**REQUEST FOR TENDER
AFRICA PAVILION – WASHROOM UPGRADES
RFT No.: TZC T 26-2020-03**

ADDENDUM 5

Project Name:	Pavilion Washroom Renovation	Addendum #:	AD-03
Project Number:	1193059	Date:	April 14, 2020
Project Address:	200 Meadowvale Road Toronto, Ontario	Client:	Toronto Zoo

Tender Addendum #E-02

A203

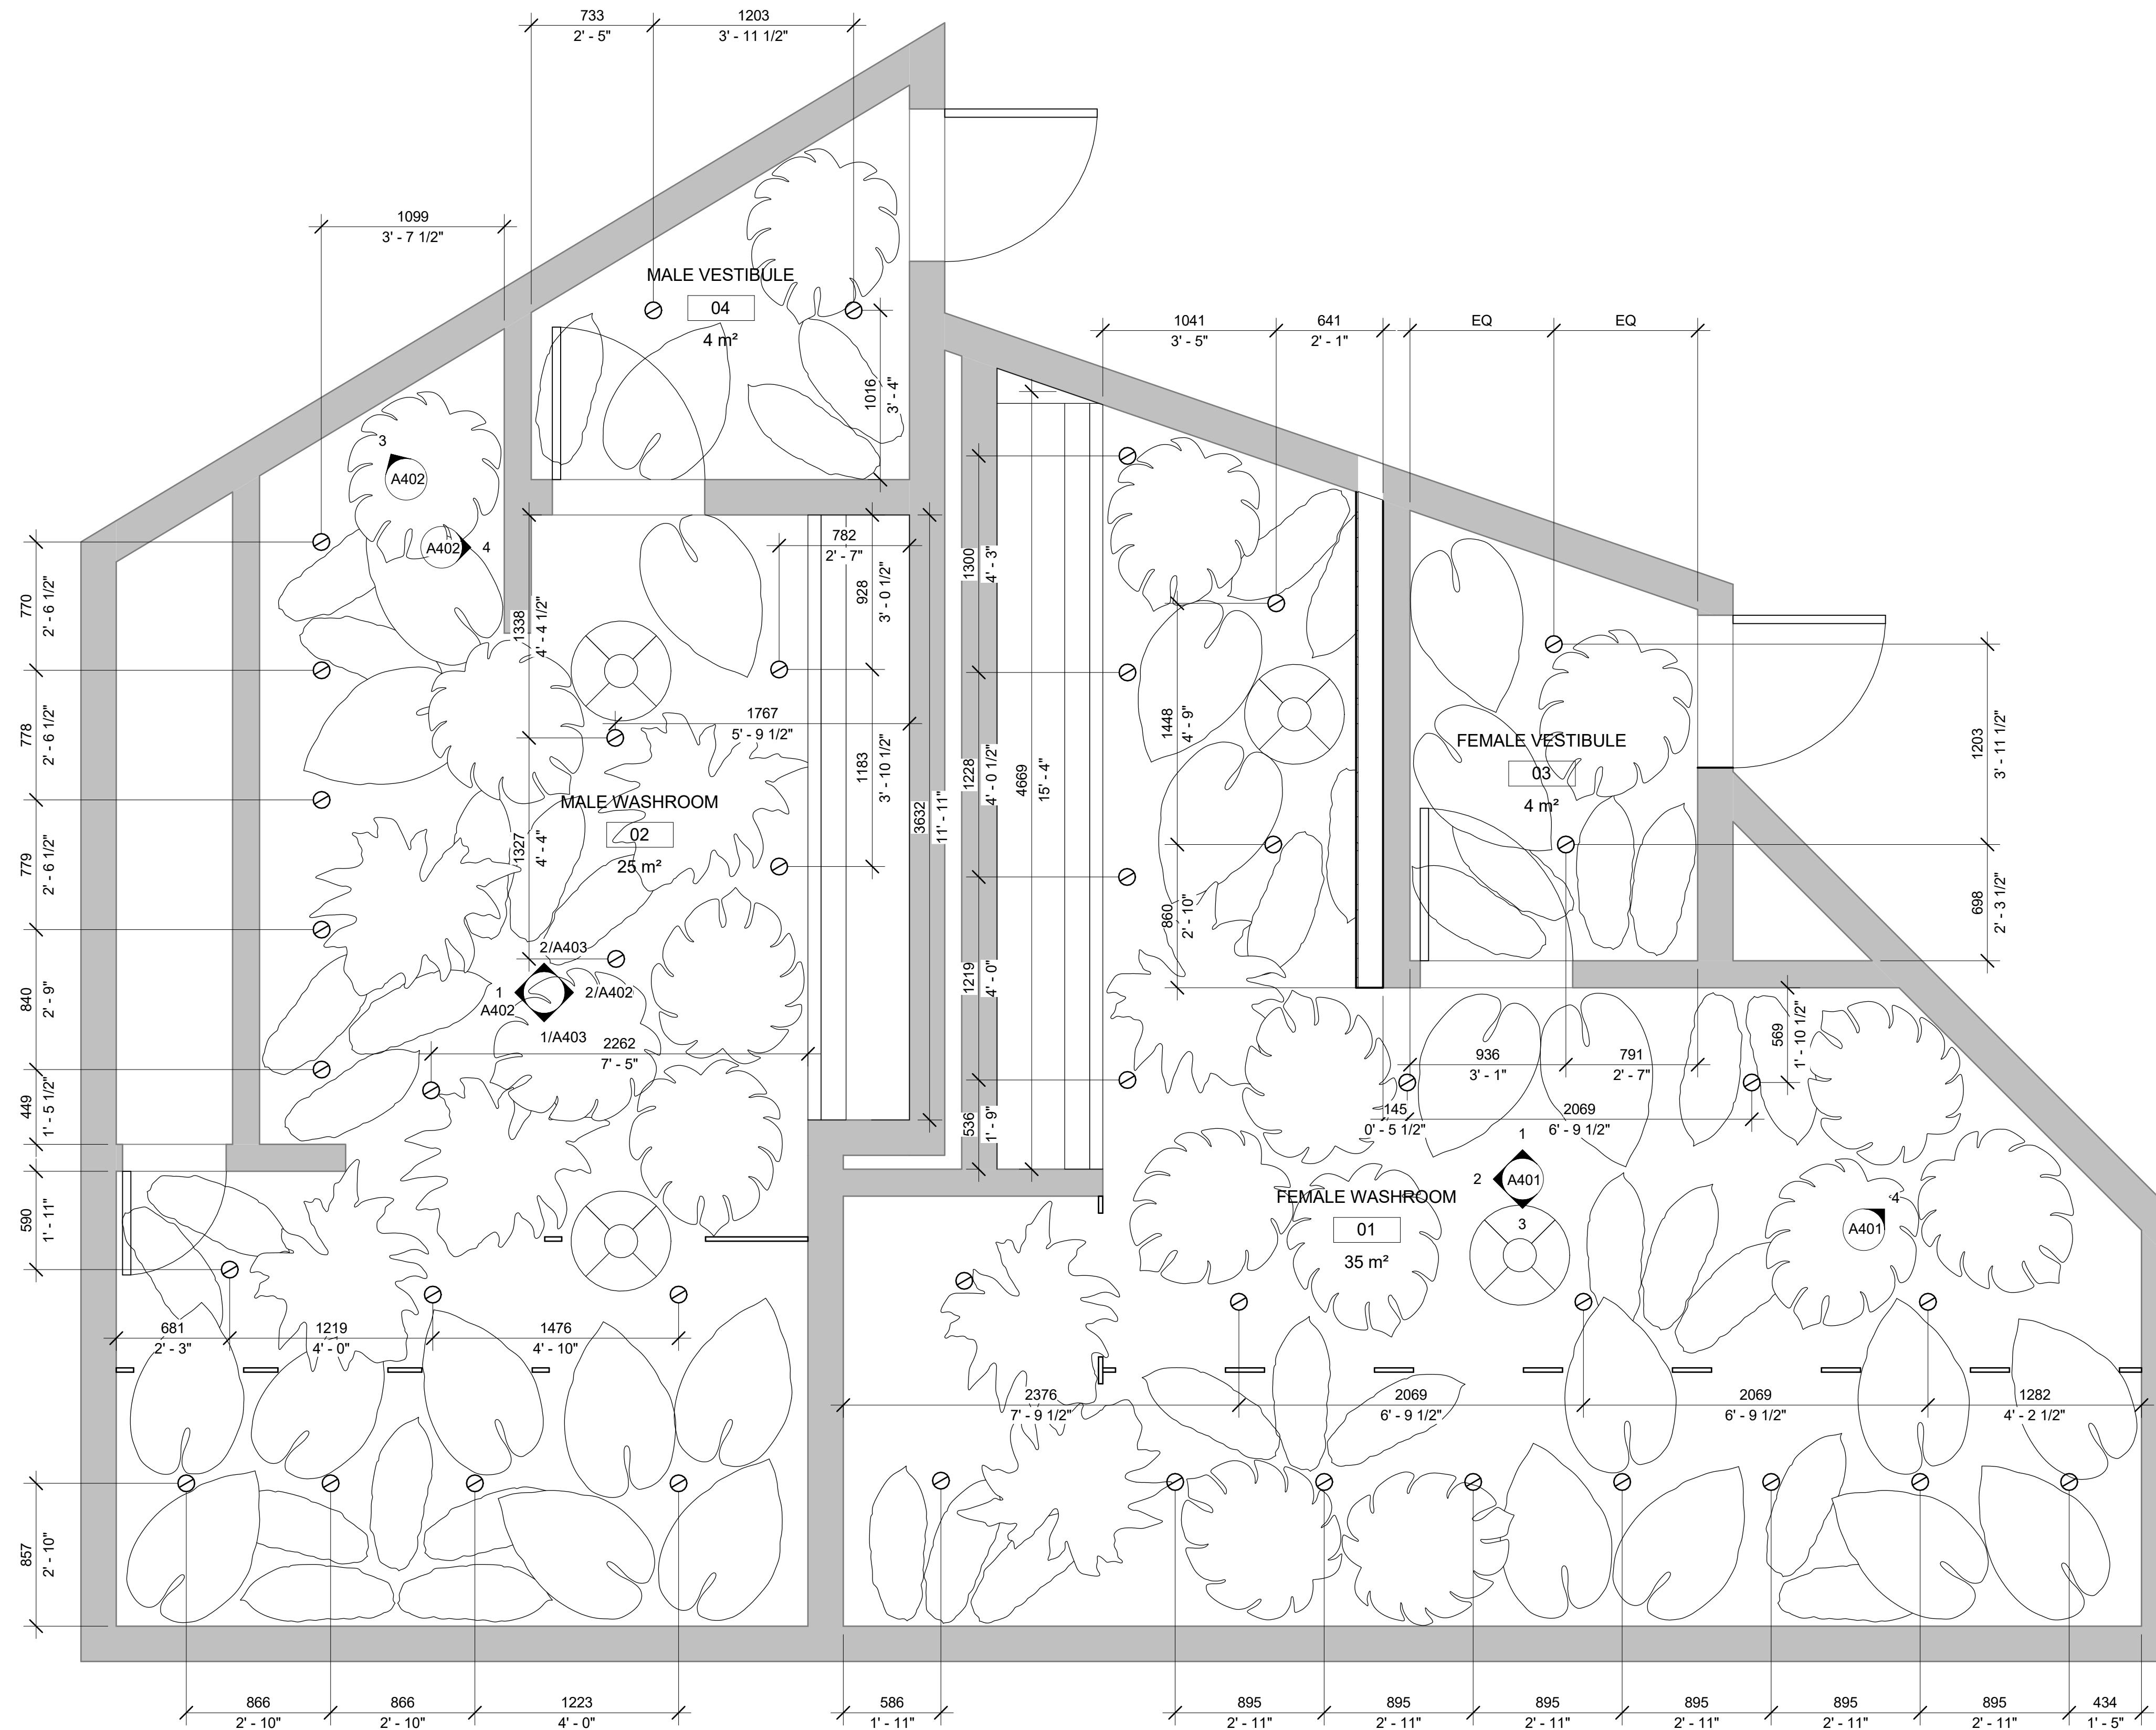
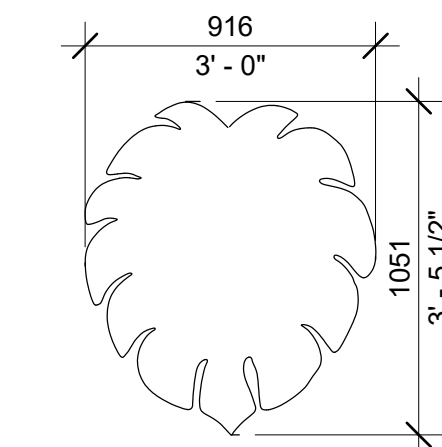
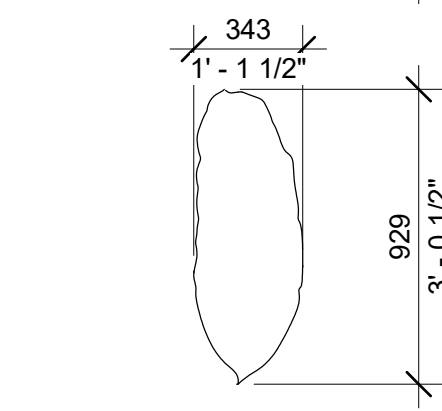
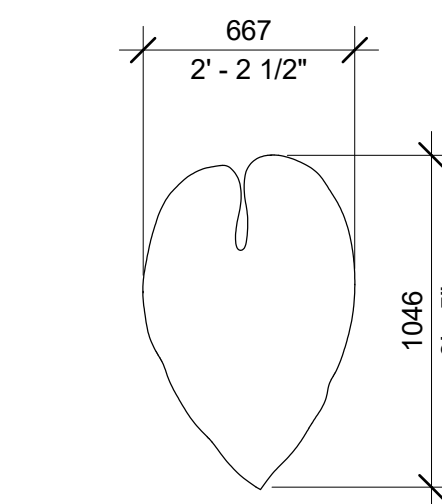
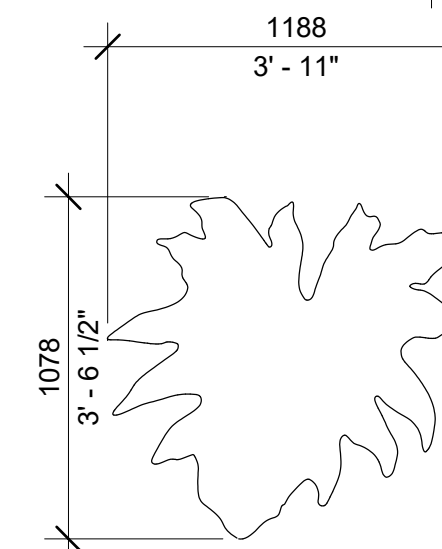
1. Contractor to refer to attached drawings for modifications to the ceiling.

- NOTE:
- LEAVES ARE TO BE MADE OF TRANSLUCENT PLEXIGLASS COLOURED ACRYLIC SHEETS THAT ARE CUT TO THE LEAF PROFILES AS ILLUSTRATED. LEAF TEMPLATE CAN BE PROVIDED AT CONTRACTOR'S REQUEST OR A SIMILAR PROFILE CAN BE SUBMITTED FOR CONSULTANTS REVIEW

- TRANSPARENT PLEXIGLASS SHEETS TO BE A MINIMUM OF 1/4" (6mm) THICK.
 - COLOUR OF LEAVES TO BE A VARIETY OF GREEN FROM LIGHT GREEN TO DARK GREEN. THREE GREEN COLOURS ARE TO BE SELECTED AND ARE TO BE CUSTOM COLOURED.

- LEAVES TO BE SUSPENDED FROM CONCRETE CEILING SLAB UTILIZING CABLE SYSTEM SUCH AS THE ORL CABLE DISPLAY SYSTEM OR APPROVED EQUIVALENT
 - HEIGHT OF LEAVES TO RANGE. AS THERE ARE FOUR LEAF PROFILES, EACH PROFILE SHALL BE INSTALLED AT A DIFFERENT HEIGHT RANGING IN 50mm +/- INTERVALS.

- COORDINATE INSTALL OF ALL LEAVES WITH CONSULTANT.
 - ENSURE SMOKE DETECTORS ARE NOT COVERED BY LEAVES
 - REFER TO ELECTRICAL DRAWINGS FOR FLOOD LIGHT LOCATIONS. FLOOD LIGHTS TO BE INSTALLED CLOSE TO U/S OF CEILING SLAB.

E-7.1
 Scale NTS

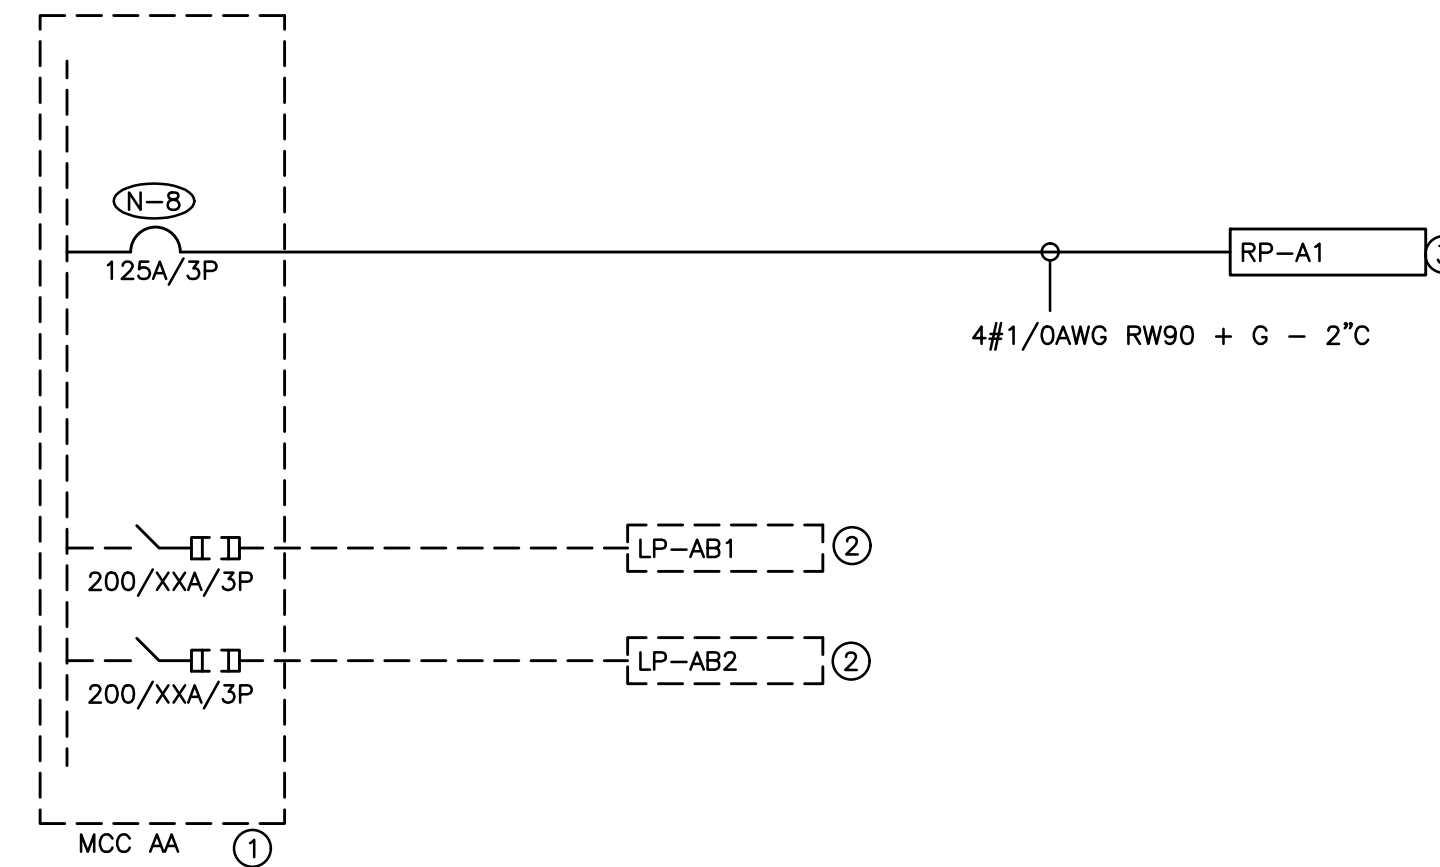
My electrician has noted that it looks like there is nothing available from supplier to retrofit a new switch into the existing MCC panel as noted on the drawings. They are suggesting an external disconnect switch, or something similar.

My electrician has noted that it looks like there is nothing available from supplier to retrofit a new switch into the existing MCC panel as noted on the drawings. They are suggesting an external disconnect switch, or something similar.

The new bucket c/w breaker, as specified is required. As detailed on drawing No. E-7.1 the electrical contractor must engage a CSA approved panel manufacturer to field retrofit the bucket c/w breaker into the existing MCC. Please refer to addendum E-02 for additional requirements.

There is no standard retrofit kit available. As detailed on drawing No. E-7.1 the electrical contractor must engage Siemens field services group or another manufacturer to field retrofit the breaker into the existing MCC and to recertify the panel bus.

- (N-7) ALL BREAKERS REQUIRED TO COMPLETE ALL SCOPES OF WORK TO BE NEW. DO NOT REUSE EXISTING BREAKERS.
- (N-8) PROVIDE NEW CIRCUIT BREAKER BUCKET C/W BREAKER INDICATED. PROVIDE REPLACEMENT PARTS, DOOR, MOUNTING HARDWARE, CONN KIT CED6 3.75" H, FILLER PLATES, PRE-FABBED MCC BUS LINKS, ETC., TO ACCOMMODATE INSTALLATION AND FOR MODIFYING EXISTING PANEL BUS. PROVIDE LUGS TO ACCOMMODATE WIRE SIZE INDICATED. PROVIDE THE SERVICE OF SIEMENS FIELD SERVICES GROUP OR EQUIVALENT CSA APPROVED MANUFACTURER OF ELECTRICAL POWER DISTRIBUTION EQUIPMENT TO EXTEND, REWORK, MODIFY AND RECERTIFY EXISTING PANEL BUS AS REQUIRED TO FACILITATE INSTALLATION OF BREAKER BUCKET C/W BREAKER PROVIDED AS PART OF THIS SCOPE OF WORK. REFER TO DETAIL NO. 1 ON DRAWING E-7.1 FOR ADDITIONAL REQUIREMENTS.

- (N-1) PHOTO ILLUSTRATES EXISTING MOTOR CONTROL CENTER INSTALLATION AND IS INCLUDED FOR REFERENCE PURPOSES ONLY.
- (N-2) FIELD RETROFIT CIRCUIT BREAKER BUCKET C/W BREAKER PROVIDED AS PART OF THIS SCOPE OF WORK INTO EXISTING CUBICLE INDICATED. PROVIDE NEW DOOR, TYPE TO MATCH EXISTING.
